**RE: COMMERCIAL FINAL DEVELOPMENT PLAN
LEE'S SUMMIT HIGH SCHOOL ADDITION AND RENOVATION
LEE'S SUMMIT, MISSOURI**

Kaw Valley Engineering, Inc. (KVE) has received comments from City of Lee's Summit for the above referenced project on December 28, 2020 and issues the following response.

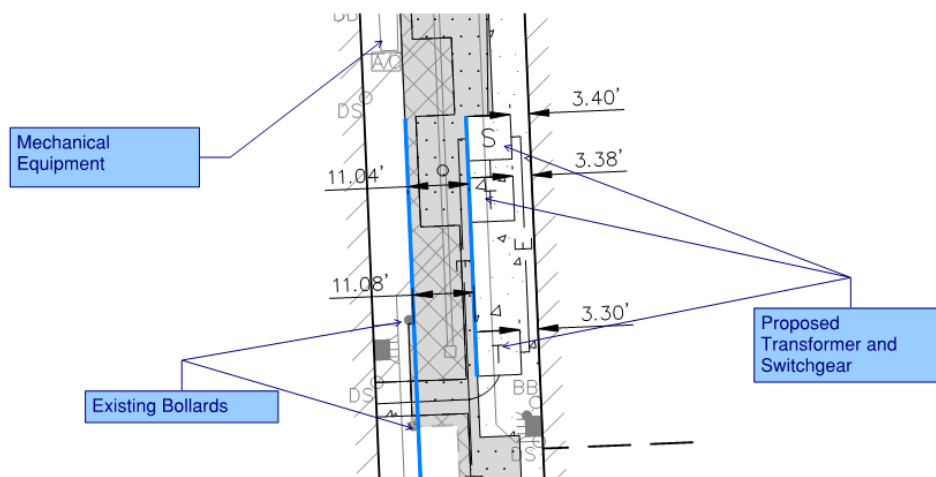
Comment 3: The lanes to and in front of Building E need to meet this requirement. **The paved road at the north end of the site has been widened to be a minimum of 20'. The IFC fire access turnaround requirements have been overlaid on Plan Sheet C130 for reference. The fire lane reduces to approximately 11' along the proposed transformers and switchgear. The track width of typical emergency vehicles is approximately 8'-2", allowing for 2'-10" of clearance from the bollards, mechanical and electrical equipment. Although not 20' wide, the drive should be passable.**
